HISTORIC AND DESIGN REVIEW COMMISSION

May 16, 2018

HDRC CASE NO: 2018-209
ADDRESS: 856 GEMBLER RD
LEGAL DESCRIPTION: NCB 10578 BLK LOT 1, P-2 & P-4 REFER TO: 10578-000-0010
ZONING: C-2 S
CITY COUNCIL DIST.: 2
APPLICANT: Salvador Garcia/NRP Group
OWNER: San Antonio Housing Trust
TYPE OF WORK: Construction of a 3-story townhome development
APPLICATION RECEIVED: April 26, 2018
60-DAY REVIEW: June 25, 2018

The applicant is requesting a Certificate of Appropriateness for approval to construct a multifamily townhome development. The proposal features eleven 3-story buildings and a one story club house.

SITE DEVELOPMENT PLAN

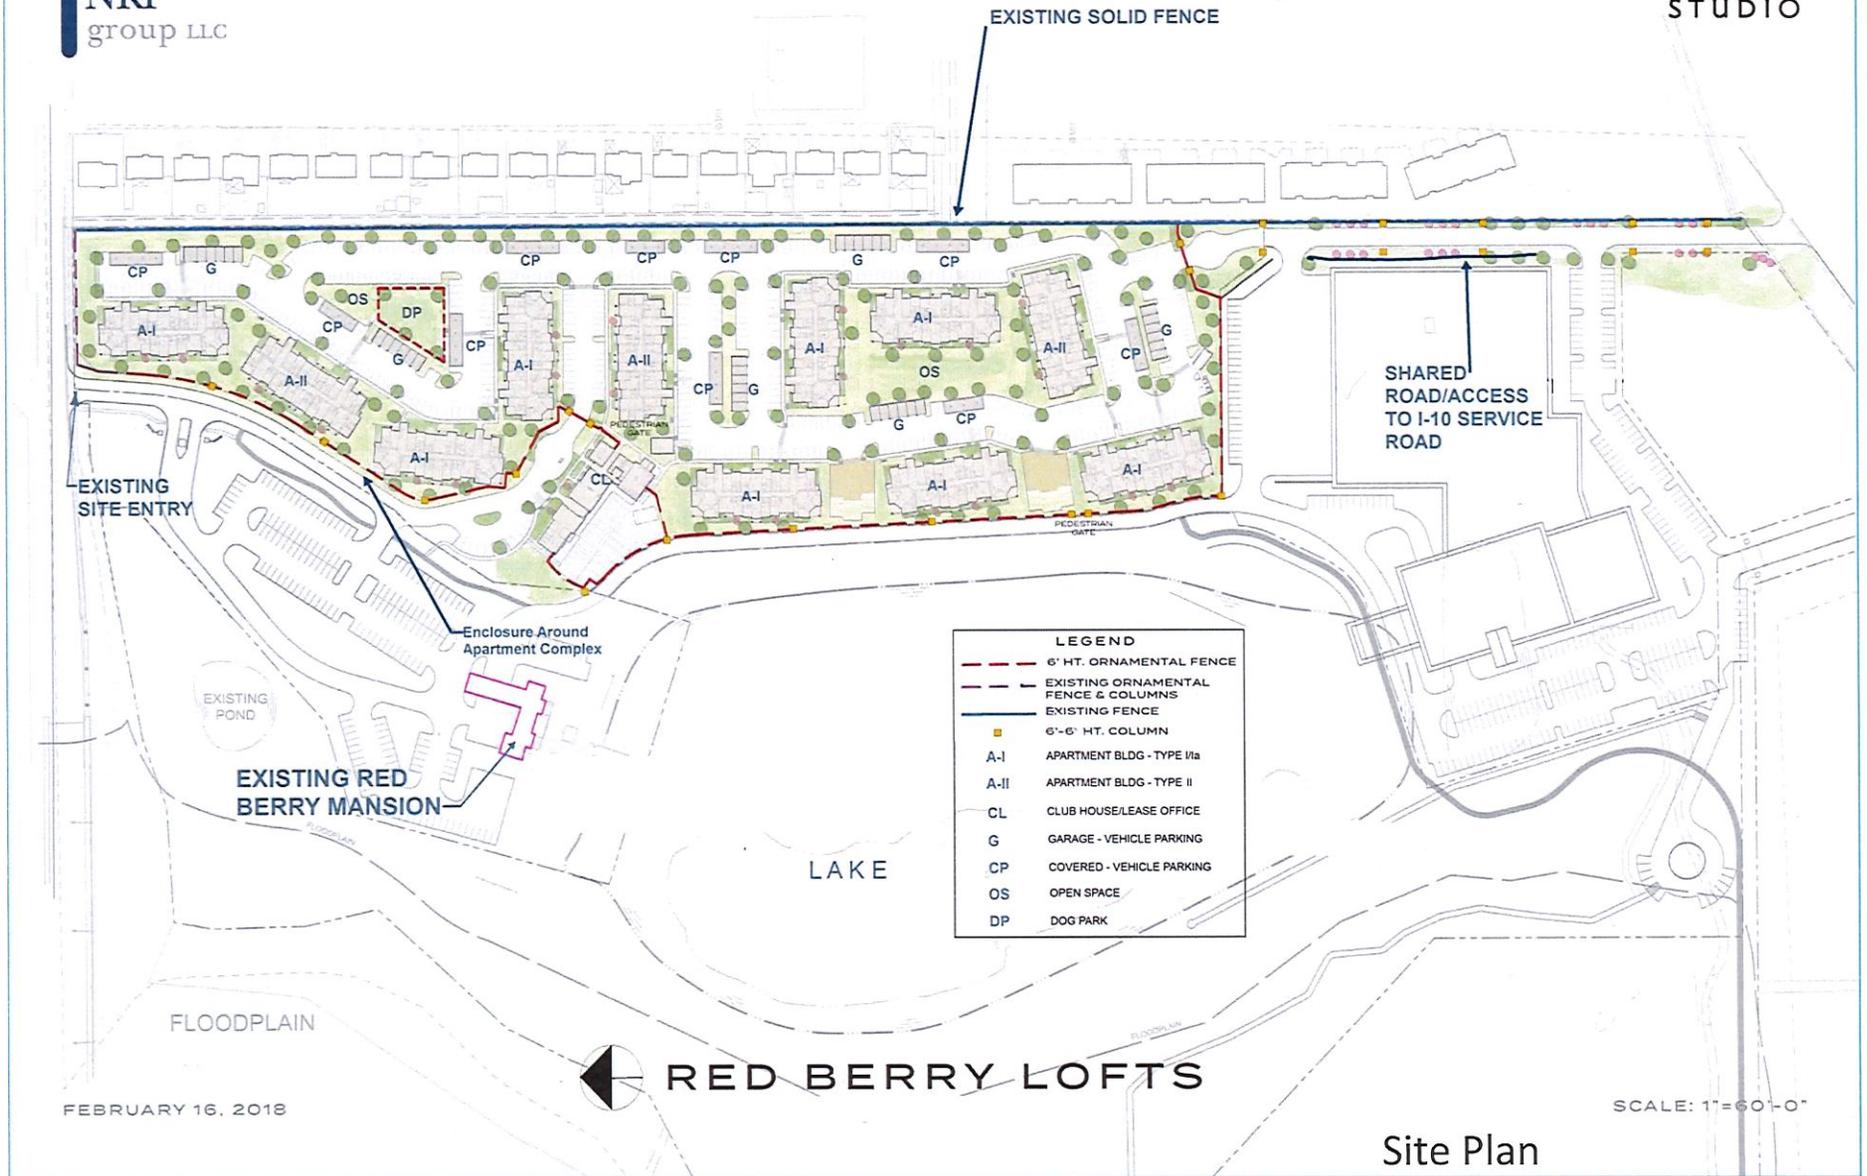
- c. PEDESTRIAN CIRCULATION – Per the UDC Section 35-672(a) in regards to pedestrian circulation, an applicant shall provide pedestrian access among properties to integrate neighborhoods. The applicant has proposed to construct pedestrian sidewalks within the site and provide pedestrian-scale gates and enclosures. This is consistent with the Guidelines.

1. BLDG TYPE Ia - FRONT ELEVATION
1/8" = 1'-0"

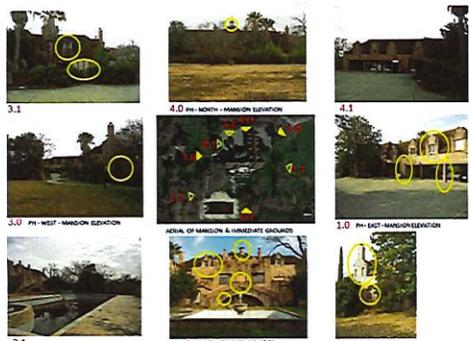
- l. **FAÇADE SEPARATION** – Based on RIO standards, proposed new construction where a façade is longer than seventy five (75) feet, additional steps must be taken to separate the façade. The applicant has proposed for the new construction to feature variations in wall planes and façade openings, including fenestration and 3-story projecting open porches. The proposed porches feature depths of approximately five (5) feet. Other variations in façade depth include recessed wall planes for specific units. Generally, the proposed design elements to separate the façade are consistent with the UDC.
